PUBLICATION INDEX

SGS 1-26

K & L SOARING, LLC
5996 STATE ROUTE 224
CAYUTA, NY 14824

Service Bulletin No. 1

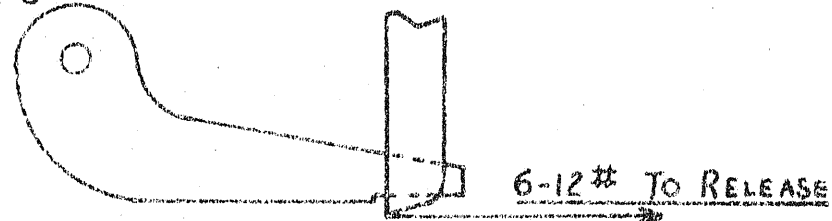
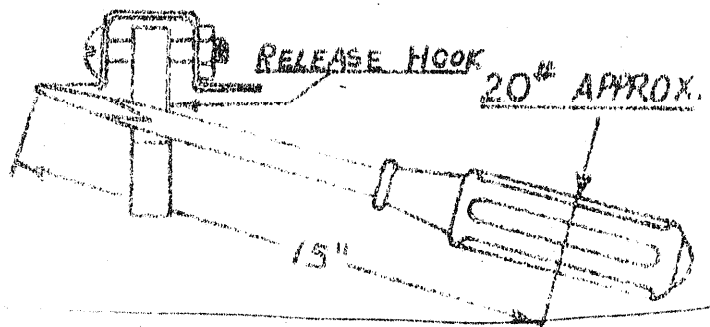
1. There are three alternate springs used in the 1-26 tow release mechanism. From field reports from owners, it appears there are cases of excessively high release operating loads. We have run tests and have determined that the best spring is our No. 1A113-1 shown below.

All 1-26's should be equipped with this spring. The installation should be checked by pulling on the release arm just below the hook with a small spring scale. This should require from 6-12 lbs. pressure to release. (See note on page 2).

The force required at the release control should be moderate. Check your control system if you feel the operating force is excessive. An additional check which is used at the factory is to operate the release while load is applied at the hook. This is done by applying pressure with a large screw driver or small bar (see sketch). Pilot should be able to release under this condition--it will, however, take more force.

ADD THIS ITEM TO
1-26 MANUAL.
Pg IV-10.3

Service Bulletin No. 2

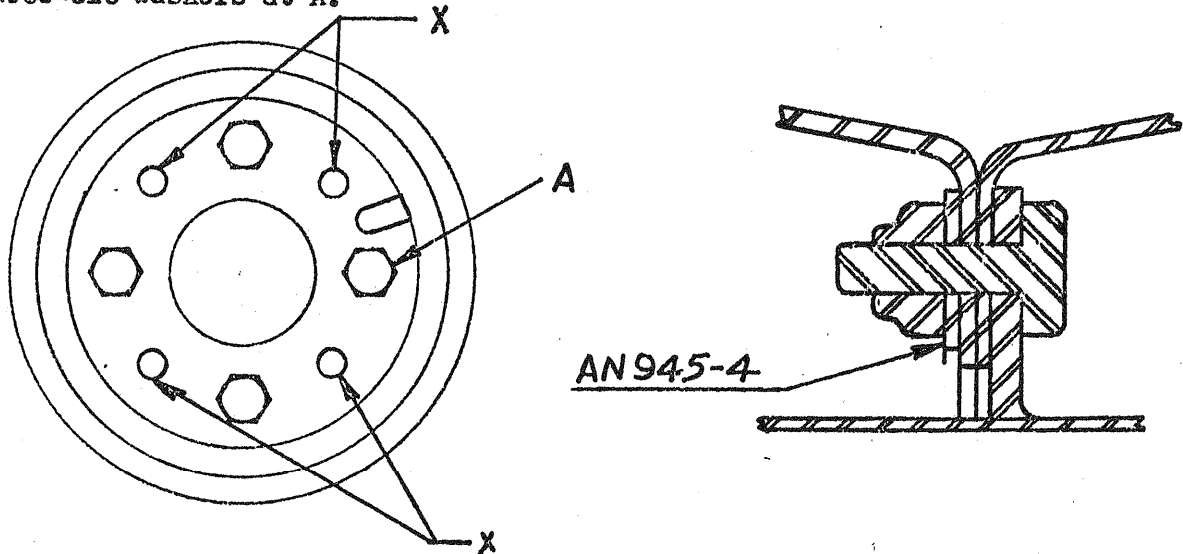
A few failures have occurred in the field to the 1-26 Wheel Assembly-- 26B201. This failure has occurred in the stamped flange at the edge of the bolt heads. To eliminate this condition, the following procedure should be used. This is not a safety of flight item, but it will eliminate the possibility of a wheel failure. The change is being incorporated in new production 1-26 sailplanes.

Procedure: Take the wheel assembly out of the ship and drill thru the four holes at X that do not have bolts with a 5/16" drill, install an AN 5-6A bolt, AN945 washer, and AN365-524 nut. Then remove the original four bolts and reinstall with AN945-4 washers. Note that all bolts will be installed with the washer between the nut and the wheel flange. (See sketch below). The one bolt next to the valve stem does not have room for the AN945 washer. On this bolt use one of the existing AN960-516 washers at A.

We are furnishing the following items to complete this modification--

4 AN5-6A, 7 AN945-4, 4 AN365-5.

Service Bulletin No. 102-26-3

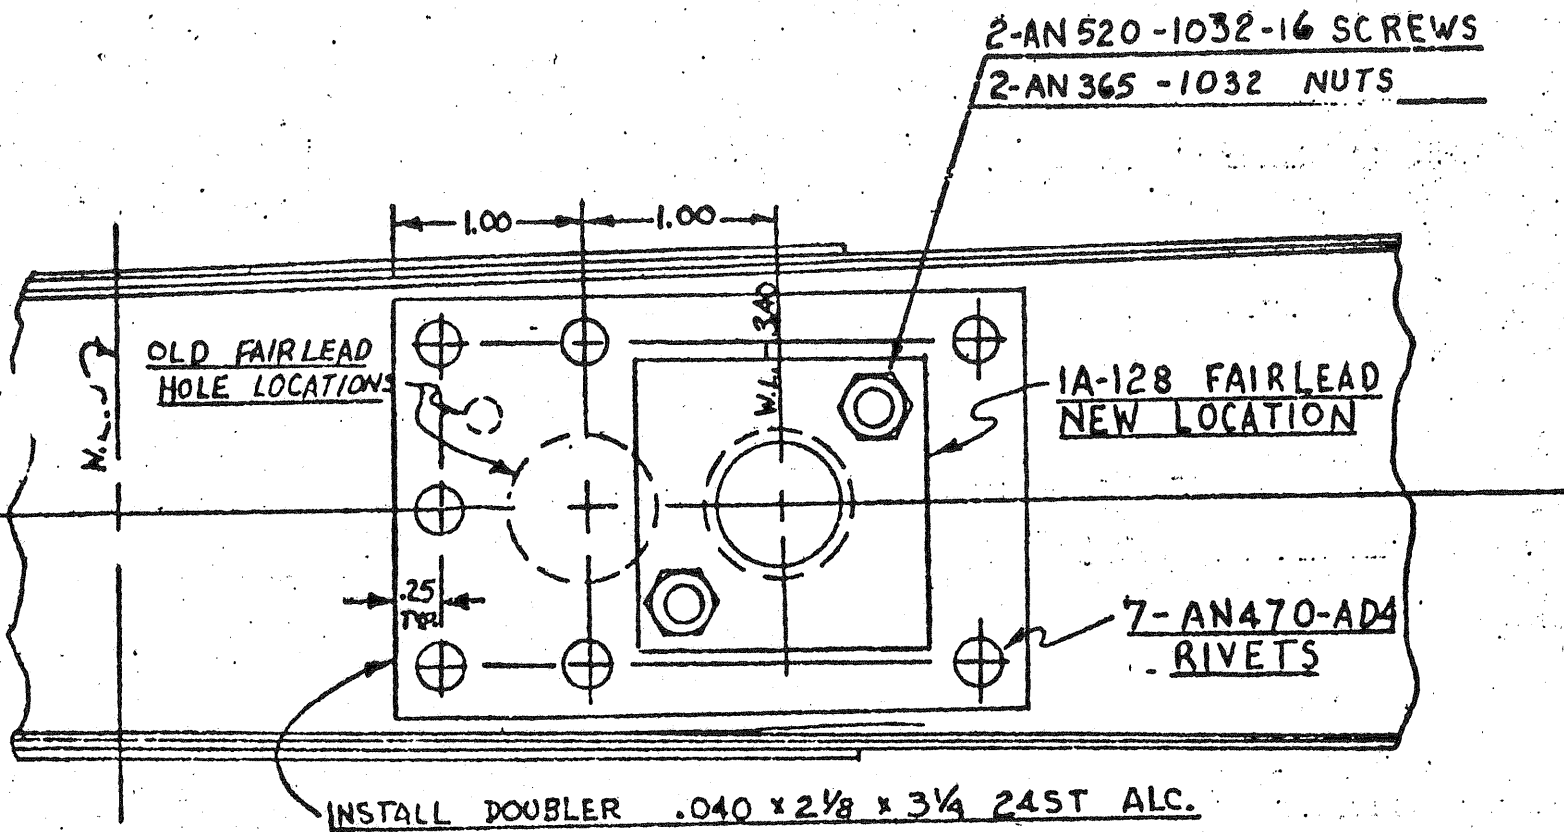
A condition has been discovered which could cause excessive wear on the 26B120-2A Elevator Control Cable at the 1A-128 Fairlead on the Fin Spar. This wear would be induced by the location of the 1A-128 Fairlead at W.L.--2.40. This condition exists on all ships to and including Ship No. 75.

The condition noted may be eliminated by relocation of the 1A-128 Fairlead to W.L. 3.40 according to the attached sketch. Material kits for this work are available upon request.

We recommend the accomplishment of this relocation at the earliest convenience and thorough inspection of the area and parts for indications of wear, each 25 hours until the relocation is made.

ENGINEERING CHANGE ORDER						CHG. LET.
TITLE:	SEAT BOTTOM					
CHG. INC.		EFFECTIVITY	OPT	PARTS AFFECTED		ECO. SERIAL
BY	W.E.F.	CARD POSTED	7.20.62	TOOLS AFFECTED		D.C.R. SERIAL
DATE	7.20.62	CHECKED	ES 2/15/62	STOCK DISPOSITION	—	DWG. NO.
						26-259
						—
						26H-318

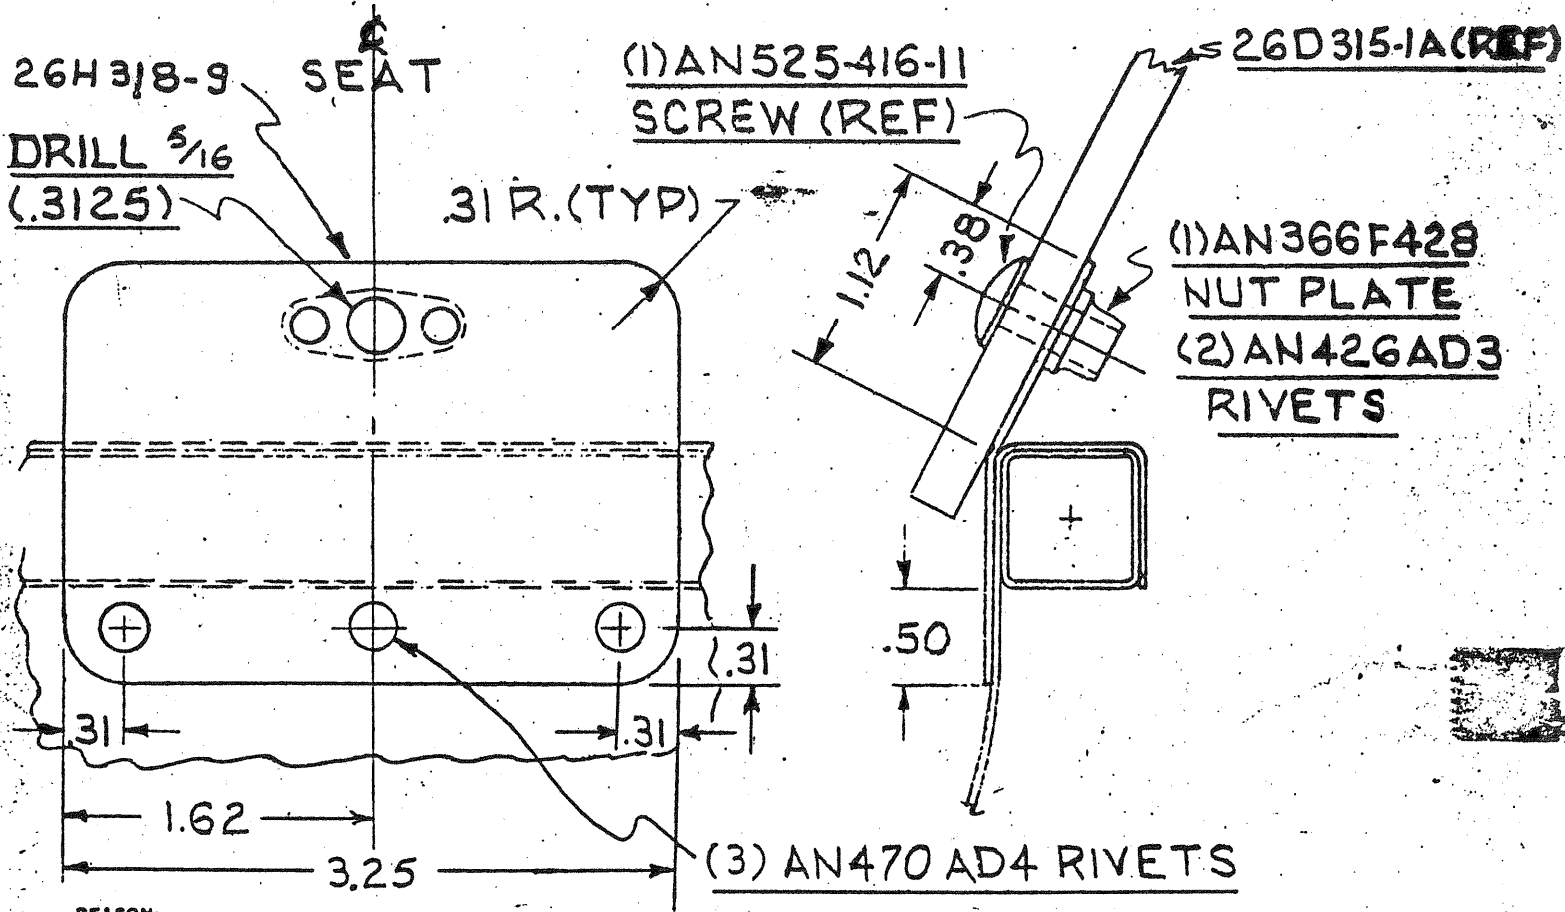
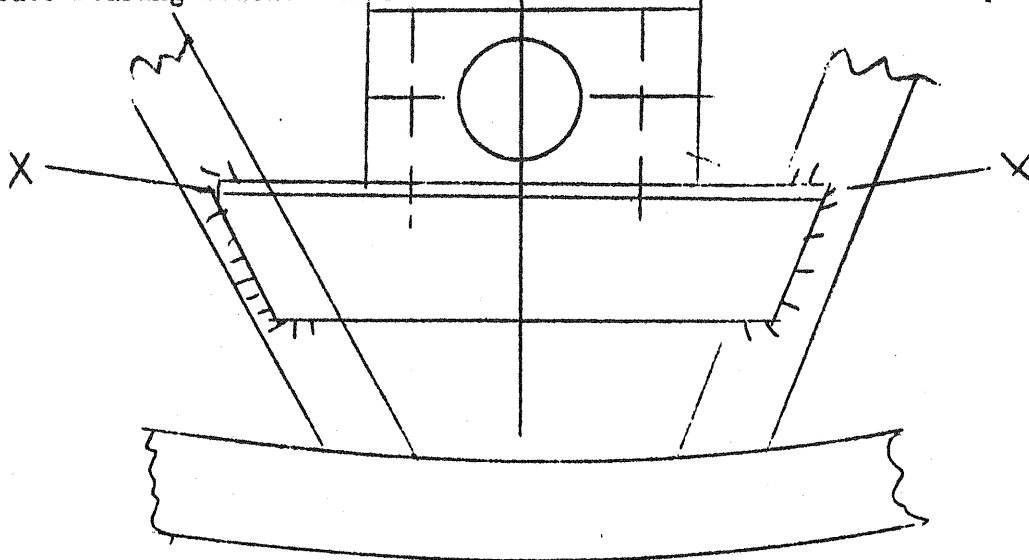
There have been cases reported where the seat back, which is held at the bottom end by aluminum clips, has disengaged and moved back suddenly. This is disconcerting to the pilot and could cause loss of control at a critical flight condition.

CHANGE: ^{REV ES 9/10/62} I. ADD ATTACH PLATE TO SEAT AS SHN.
MAKE FROM .040 2024-T3 ALC

I. TO PROVIDE ADDITIONAL ATTACHMENT FOR SEAT BACK.

FIGURE 1 – ENGAGEMENT OF TOW HOOK INTO RELEASE ARM

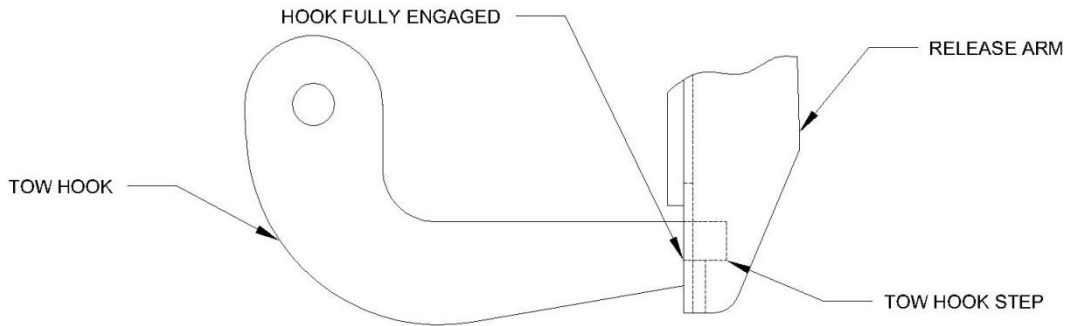
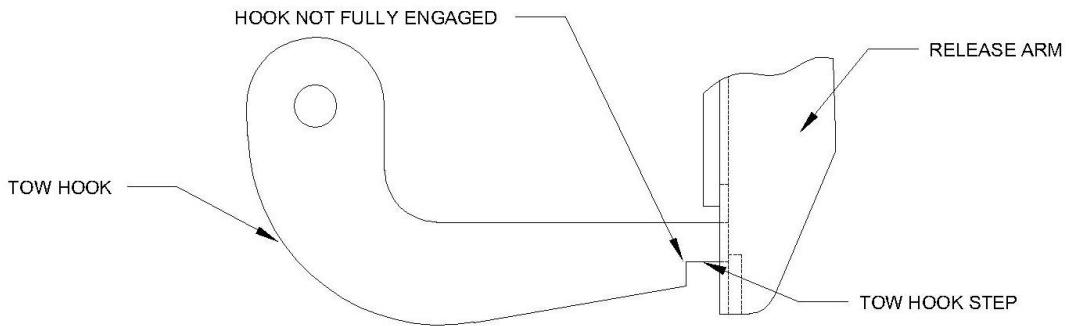
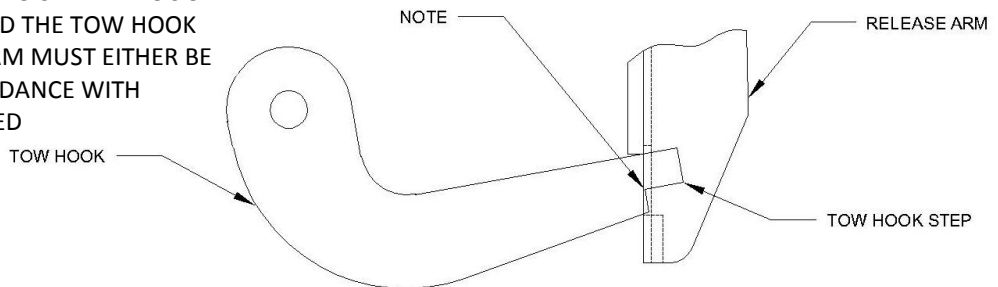
- Figure 1 shows the proper attachment of the tow hook into the release arm. Note that the step of the tow hook should seat against the release arm. The tow hook step must fully engage the release arm to allow the release assembly to function properly. The tow hook must not be allowed to extend through the release arm beyond the step on the hook as shown in Figure 1, View C.

IF TOW HOOK IS ABLE TO SLIDE THROUGH RELEASE ARM, BEYOND THE TOW HOOK STEP, THE RELEASE ARM MUST EITHER BE REWORKED IN ACCORDANCE WITH FIGURE 3, OR REPLACED

FIGURE 2 – TOW HOOK INSPECTION AND REWORK (SHEET 1 OF 2)

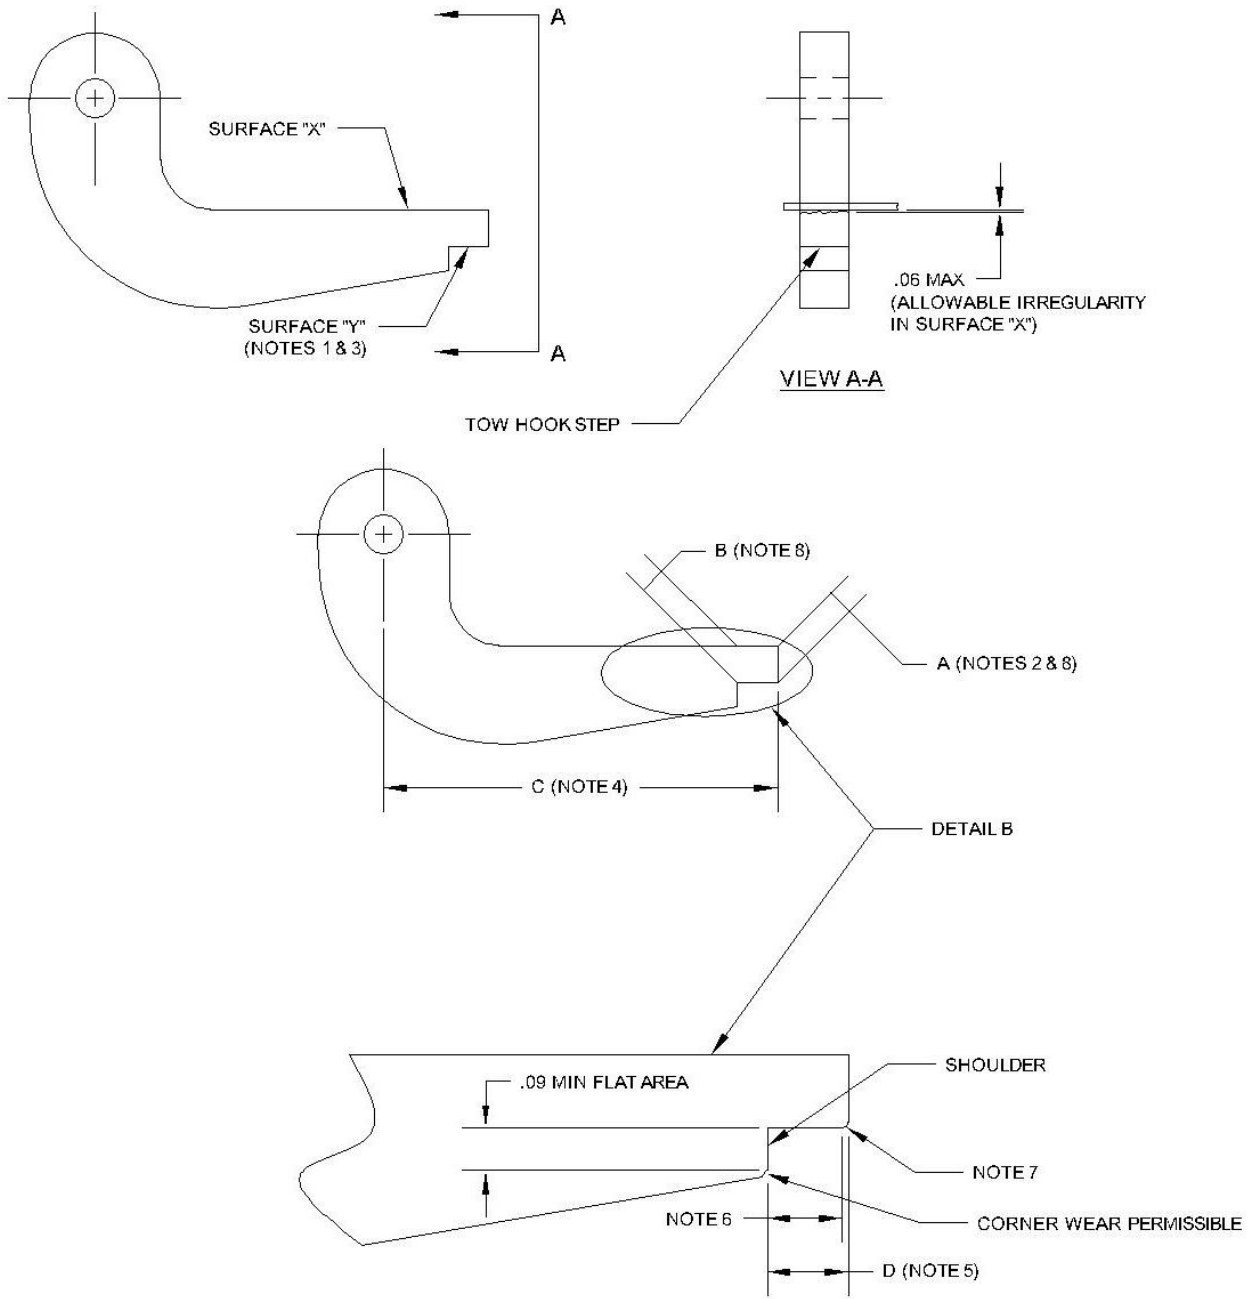
- Proper engagement of the tow hook into the release arm is shown in Figure 1, View A, and Figure 4. Excessive wear of the tow hook step could result in improper engagement. Figure 2 of this bulletin provides inspection data and wear limits for the tow hook. Tow hooks which do not meet the specified limits must either be reworked to obtain dimensions (as specified in Figure 2) or replaced.
 - If tow hooks is able to slide into the release arm, beyond the tow hook step, as shown by Figure 1, View C, the release arm must either be reworked with a slug as specified in Figure 3, or replaced.
- c. Inspect tow hook for wear in accordance with Figure 2 of this bulletin.

- d. If tow hook dimensions are not within limits specified in Figure 2, either rework the tow hook to obtain dimensions (as specified in Figure 2) or replace it with a new or serviceable, used tow hook
- e. Engage tow hook into release arm. Ensure that the tow hook properly engages as shown in Figure 1, View A.
- f. If tow hook is unable to completely engage (shown by Figure 1, View B) shorten the rubber bumper stop between the release knob and the instrument panel to allow the release assembly to close further.

1. IF WEAR OCCURS ON SURFACE "Y" IT MUST BE POLISHED FLAT WITHIN TOLERANCES PROVIDED IN FIGURE 2 (SHEET 1). IF THE HOOK CANNOT MEET THESE REQUIRED DIMENSIONS IT MUST BE REPLACED. UNDER NO CONDITIONS SHOULD SURFACE "X" BE POLISHED OR MACHINED TO CHANGE ITS ANGLE.

2. DIMENSION "A" ON STD 10232-001 HOOK SHALL BE .21 INCHES MIN. & .28 INCHES MAX. DIMENSION "A" ON STD 1A218-1A, STD 1B221-3, & R-200-9A HOOKS SHALL BE .25 INCHES MIN. & .31 INCHES MAX.

3. SURFACE "Y" MUST REMAIN FLAT, SMOOTH, AND WITHIN TOLERANCES SHOWN ON SHEET 1. (SEE ILLUSTRATION).
4. DIMENSION "C" ON STD 10232-001 HOOK SHALL BE $2.06 \pm .03$ INCHES. DIMENSION "C" ON STD 1A218-1A, STD 1B221-3, & R-200-9A SHALL BE $3.00 \pm .03$ INCHES.

5. DIMENSION "D" ON STD 10232-001 HOOK SHALL BE $.25 \pm .03$ INCHES. DIMENSION "D" ON STD 1A218-1A, STD 1B221-3, & R-200-9A SHALL BE $.31 \pm .03$ INCHES.

6. HOOK MUST REMAIN FLAT IN THIS AREA FOR A MIN. OF .21 INCHES FROM SHOULDER OF HOOK.
7. WEAR OUTSIDE OF THE .21 MIN. FLAT AREA IS PERMISSABLE.
8. DIMENSION "B" MUST BE EQUAL TO DIMENSION "A", OR LESS THAN DIMENSION "A" BY NO MORE THAN .015 INCHES AND CANNOT BE GREATER THAN DIMENSION "A".

9. ALL SURFACES EXCEPT SURFACE "X" MAY BE FILLED TO OBTAIN REQUIRED DIMENSIONS.

FIGURE 3 - REWORK OF RELEASE ARM

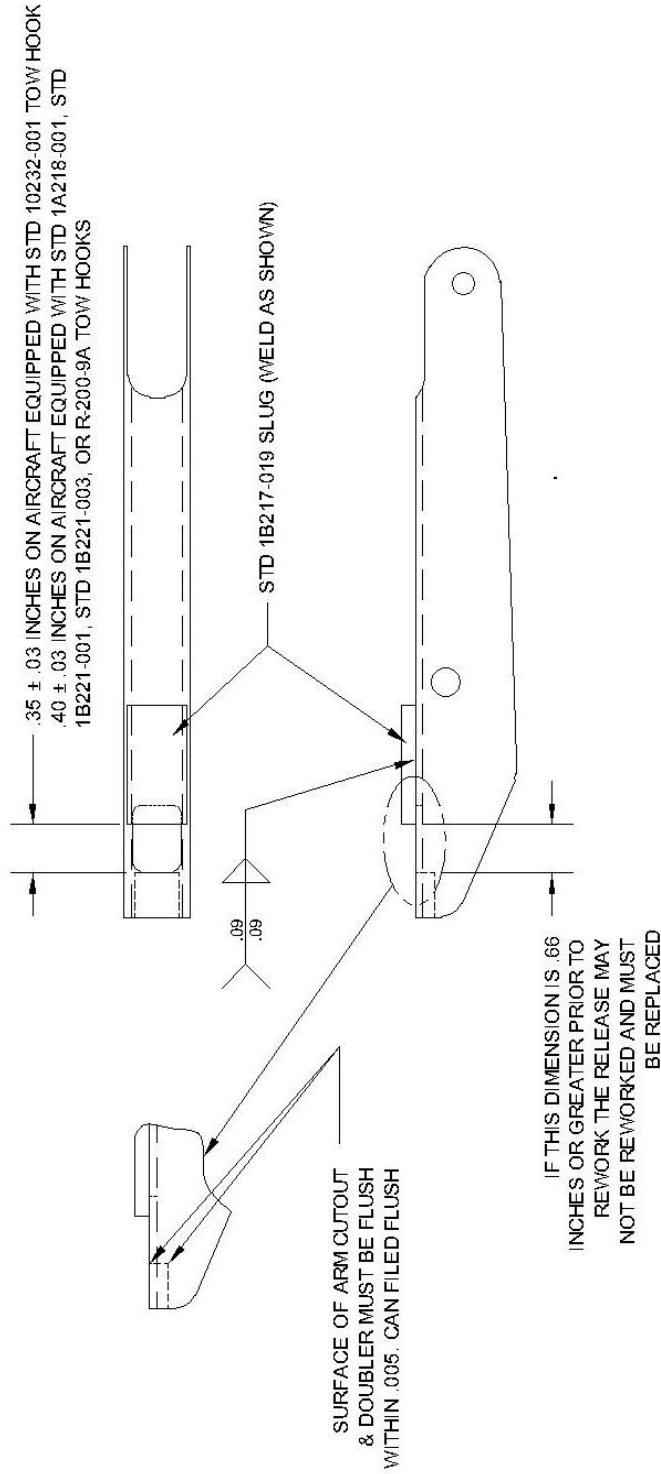
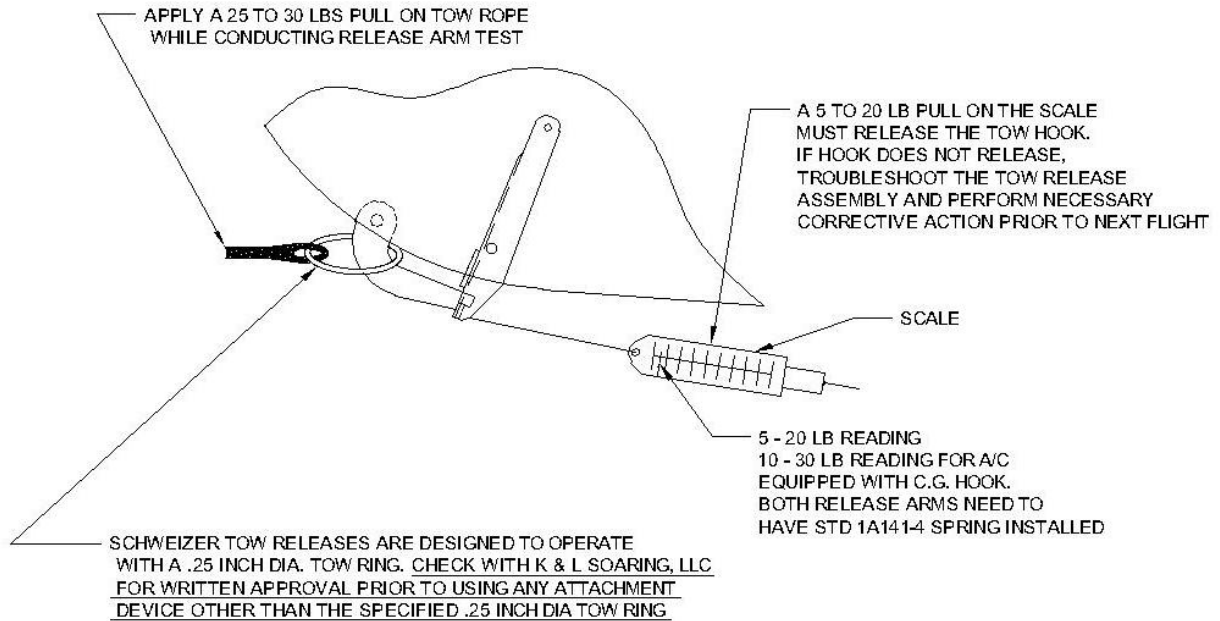
- g. If tow hook is able to travel too far inboard as shown in Figure 1, View C, disengage tow hook from release arm and measure the length of the release arm slot
- h. If dimension is less than 0.66 inch, rework release arm by welding on 1B-217-19 slug at location shown in Figure 3. (Release arm may be replaced as an alternate to welding on slug)
- i. If length of release arm slot is greater than 0.66 inch, replace release arm.
- j. Perform a thorough inspection of the tow hook installation in accordance with the 100 hour inspection requirements listed in Table 2 of this bulletin.
- k. Repair or replace unserviceable component(s), as required
- l. Record compliance with Part I of this Service Bulletin in Aircraft Log Book.

**NOTE: STD 1B217-019 SLUG IS AVAILABLE FROM K & L SOARING, LLC
 0.125 X 0.5 X 1.0 4130N STEEL**

**NOTE: ALL TOW RELEASE ARMS MUST BE REWORKED AS SHOWN ABOVE OR
 REPLACED WITH THE PROPER SUPERSEDING ARM AS SPECIFIED IN TABLE 1**

FIGURE 4 - PULL TEST OF TOW RELEASE ASSEMBLY

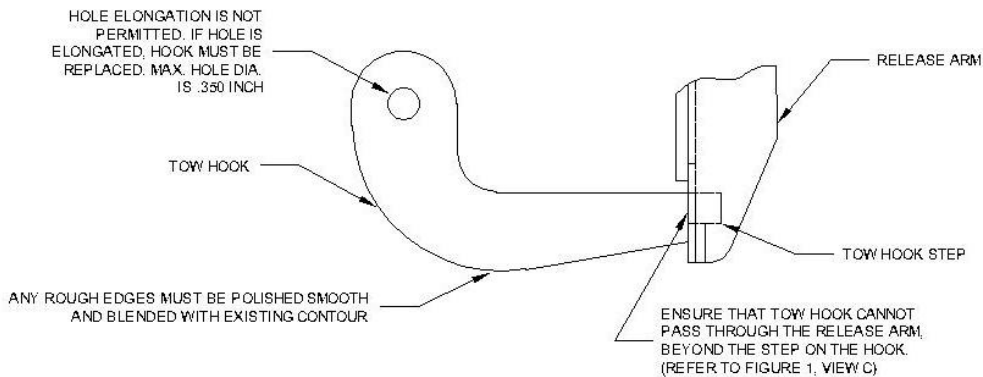
Perform a release check for proper release tension in accordance with Figure 4.			X
Lubricate attach hardware for tow hook and release arm.		X	X
Lubricate guide-tubes in release control with dry stick type lubricant.		X	X
Insure that tow hook moves freely on pivot bolt.	X	X	X

NOTE: IF RELEASE LOADS ARE TOO HIGH WITH C.G. SYSTEM IT IS PERMISSIBLE TO ADD A LINK TO SHORTEN STD 1A141-2 SPRING. LINK SHOULD BE MADE AS SHOWN BELOW. IF REQUIRED THEY SHOULD BE ADDED TO BOTH RELEASE ARMS TO BALANCE BOTH RELEASE SPRINGS
